Service Bulletin

Reference # 2012-003

Subject: BI-ANNUAL REPLACEMENT OF OUTBOARD SLEWING BEARING BOLTS:

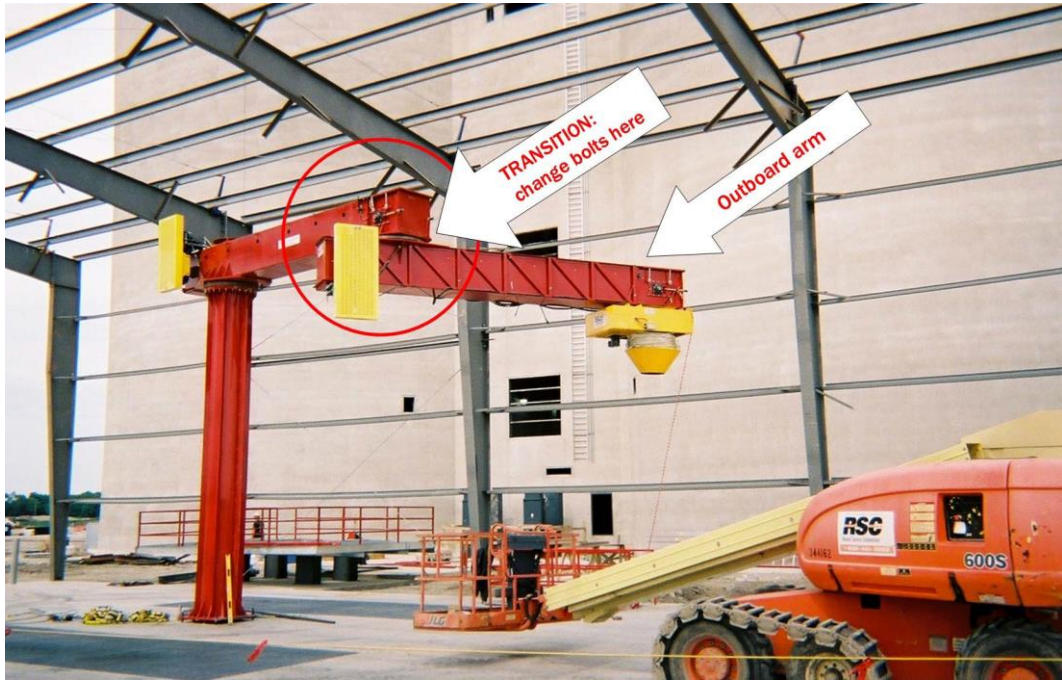
*Normal operating use of an articulated loading conveyor can cause the Grade 8 bolts used to attach the outboard conveyor arm to the transition slewing bearing to harden and crack. As a result, for safety reasons, we strongly recommend replacing these bolts every 2 years. **Warning: Bolt failure could cause the loading arm to break free from the slewing bearing and fall resulting in damage or personal injury.***

- 1) Locate the (2) access holes on the transition between the main conveyor and the outboard conveyor. There is (1) access holes on each side of conveyor.
- 2) Rotate the outboard conveyor arm until the bolt head is in view in the access hole.
- 3) Use a $\frac{3}{4}$ " socket to remove the bolt.
- 4) Immediately replace the bolt with a new $\frac{1}{2}$ " diameter, 13 x 3" Grade 8 bolt.
- 5) Torque the bolt to 70 ft. lbs. if the bolt is pre-lubricated or 110 ft. lbs. if the bolt is dry.
- 6) Mark the bolt with a magic marker to indicate that it's been replaced.
- 7) Locate the access hole on the opposite side of the loading arm and move the loading arm until a bolt head is visible through that access hole.
Repeat steps 3 through 6.
- 8) Rotate the outboard arm to the next set of bolts and repeat steps 3 through 7 until all bolts have been changed out.
